Company	Trenz Electronic GmbH
PCN Number	PCN-20230327
Title	TE0745-02 to TE0745-03 Hardware Revision Change
Subject	Hardware Revision Change
Issue Date	2023-06-27

PCN-20230327 TE0745-02 to
TE0745-03 Hardware Revision
Change

Document Rev: v.17

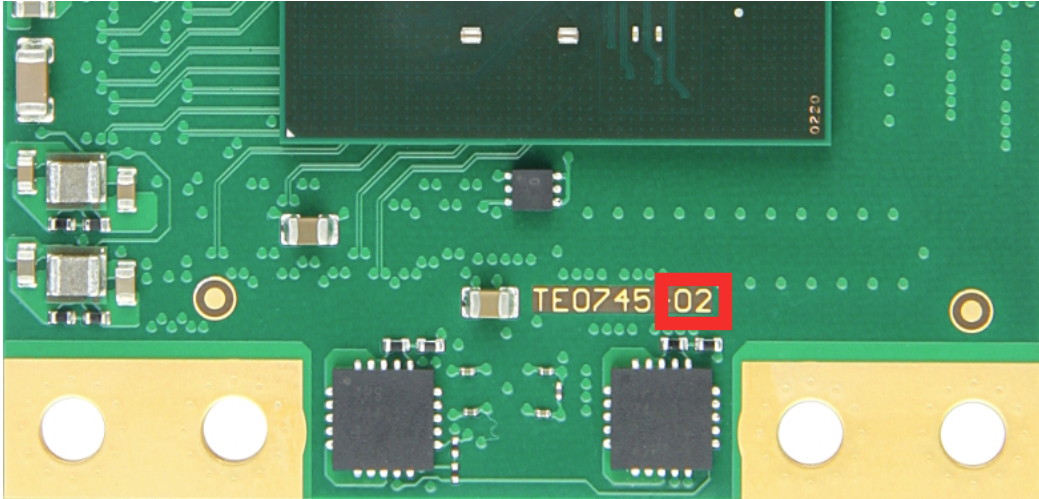
2.33 #33 Change PCB color from black to standard green.
